Change No. 14
License Nos. DPR-32
and DPR-37

CHANGE NO. 14 TO THE TECHNICAL SPECIFICATIONS

OPERATING LICENSES NOS. DPR-32 AND DPR-37

DOCKET NOS. 50-280 AND 50-281

FIGURE 6.1-1

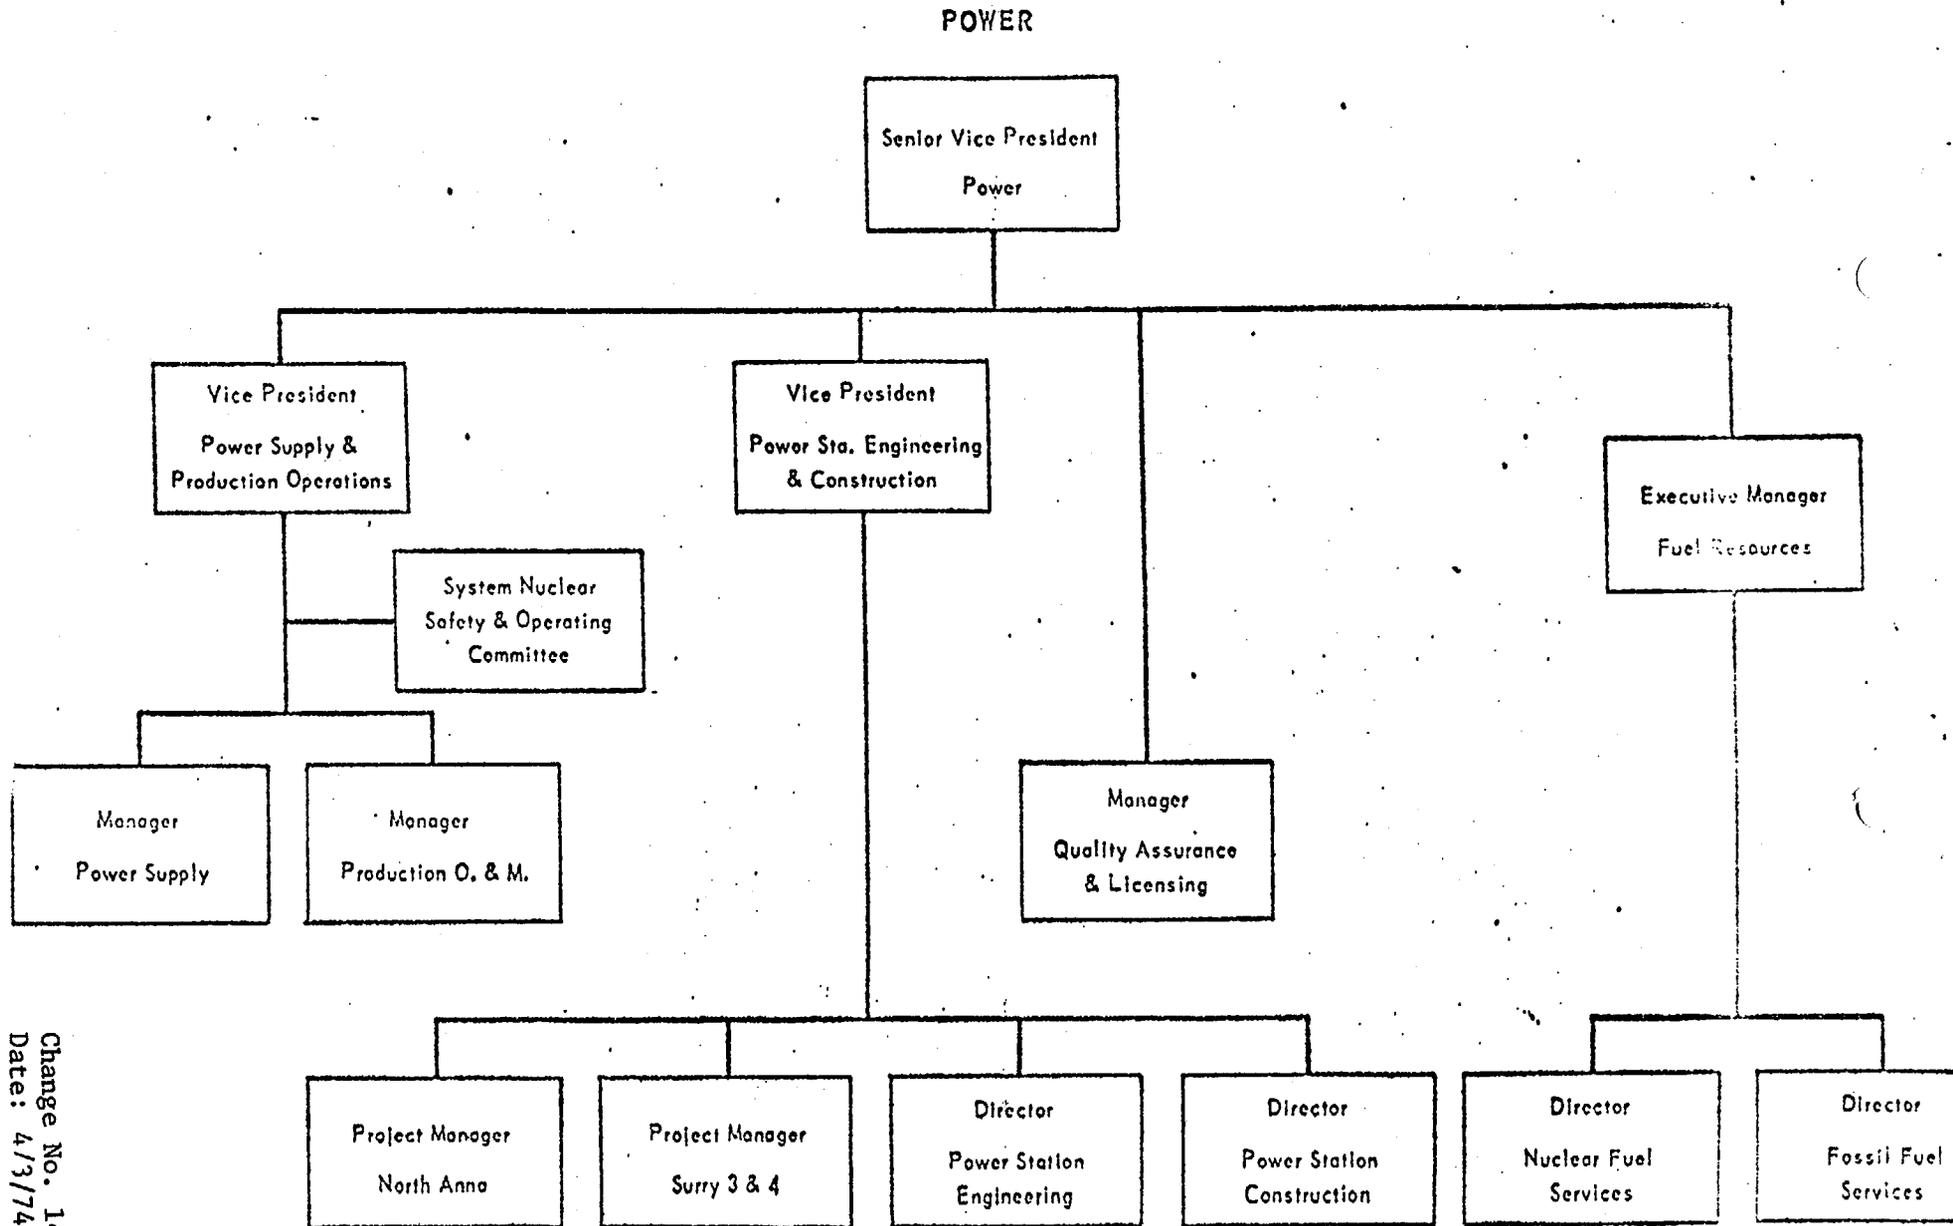
4. Replace Figure 6.1-1 with the attached figure.

The proposed changes to Section 6.1-1 reflect organizational changes that went into effect within VEPCO on January 1, 1974, and are found acceptable.
